Subject: Juniper Ridge Landfill Expansion Application, MEDEP #S-020700-WD-BI-N Follow-up to Department Staff's Responses to the March 4, 2016 Submittal on Staff's Review Comments as Presented in the Department's April 5, 2016 Letter

BGS AND NEWSME'S RESPONSE TO MEDEP'S APRIL 1, 2016 TECHNICAL MEMORANDA

I. April 1, 2016 Technical Memorandum Authored by Mr. Richard Behr

SKAPS, Industries
Compression Creep Test Results via SIM
Product Code: TN-330

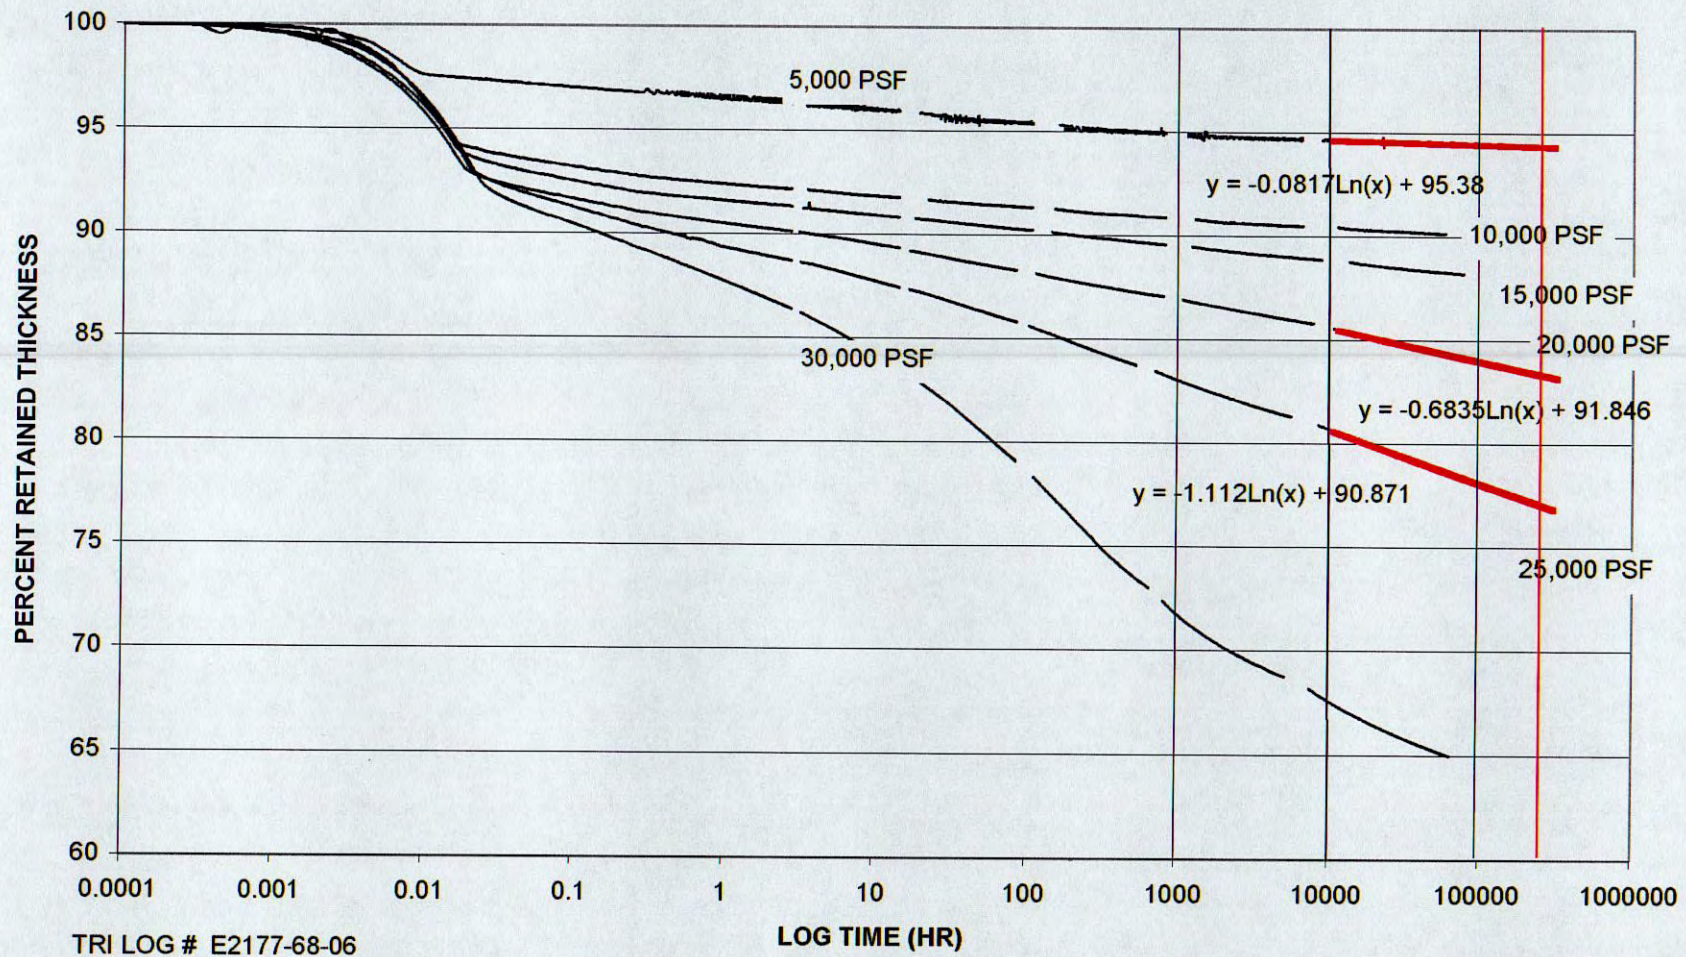
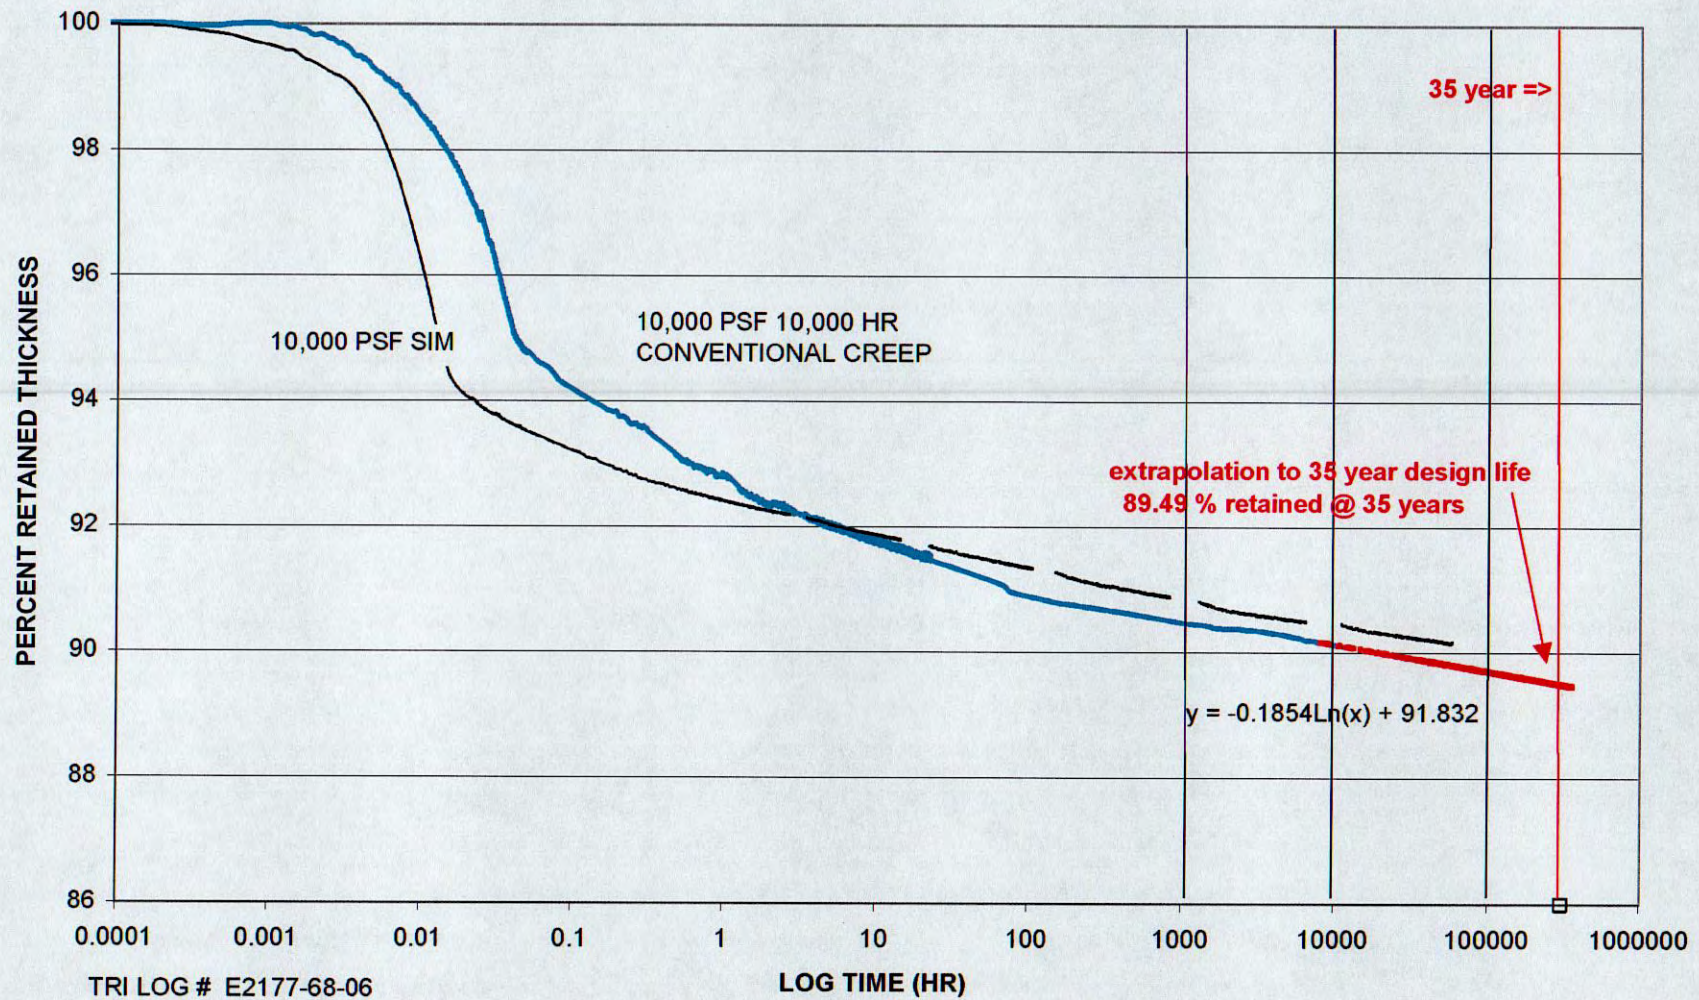
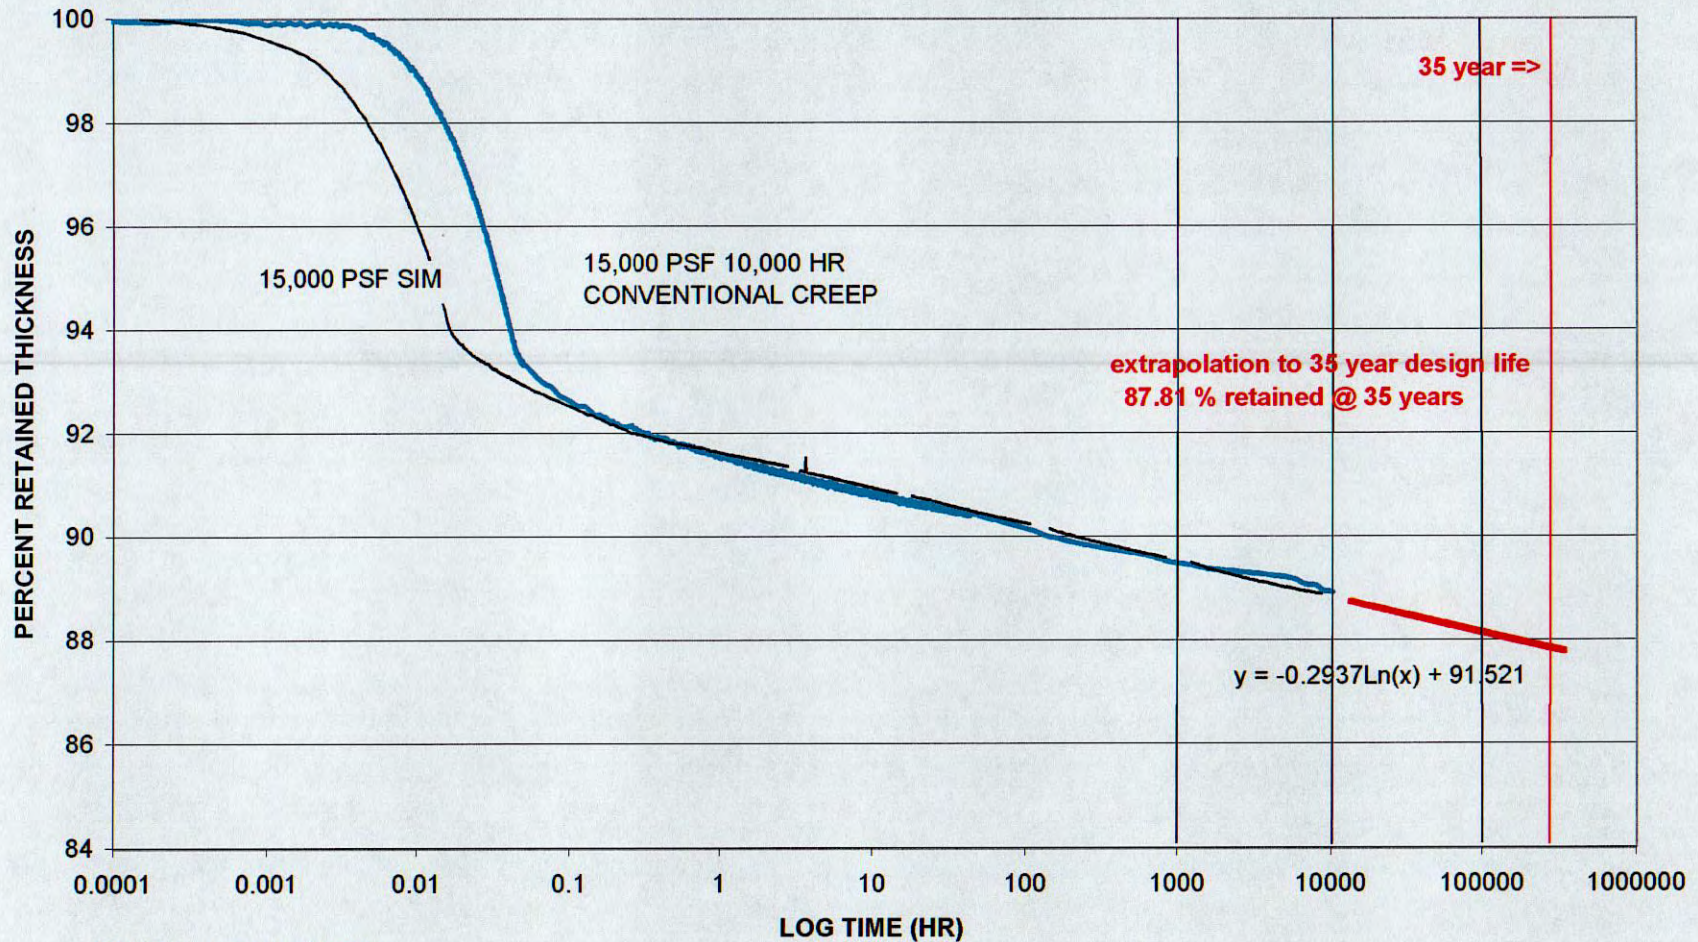
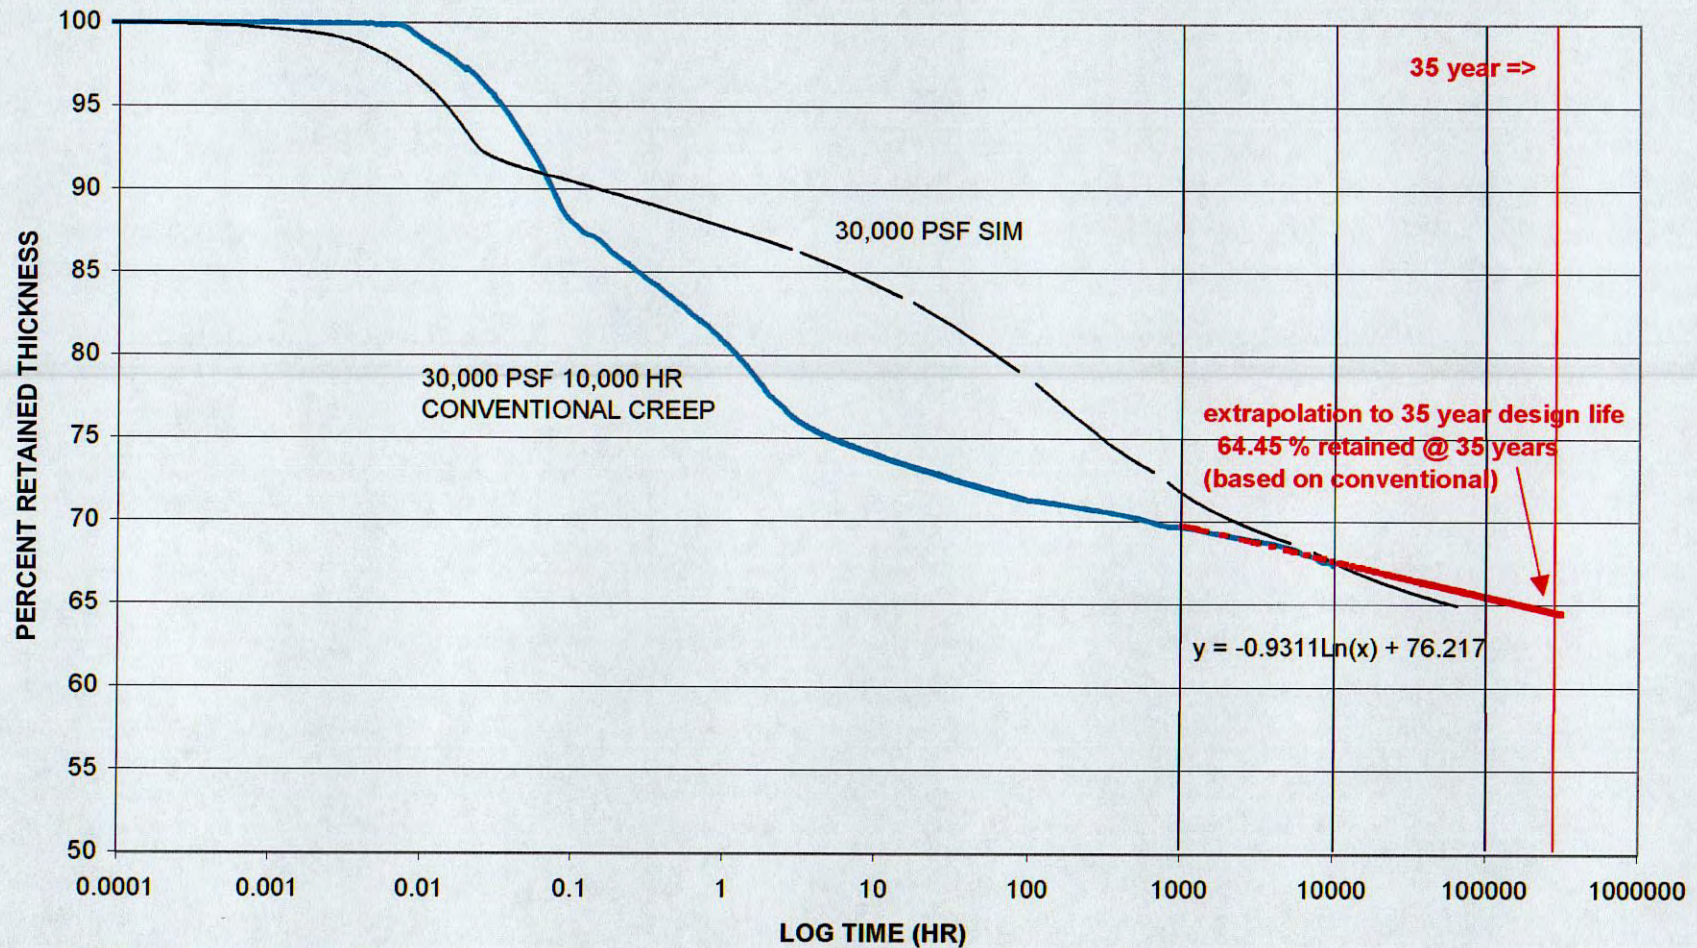
MEDEP Follow-on comment II.L.1: Appropriate references justifying the reduction factors for chemical clogging, biological clogging, and intrusion have been provided. Reference is made to SIM testing completed by TRI that concluded that a reduction factor for creep as low as 1.1 is justified at normal loads of 15,000 psf. We request a summary of the referenced testing program.

Applicants' Response: Included in Attachment SME-D8 is a summary of the reference testing program.
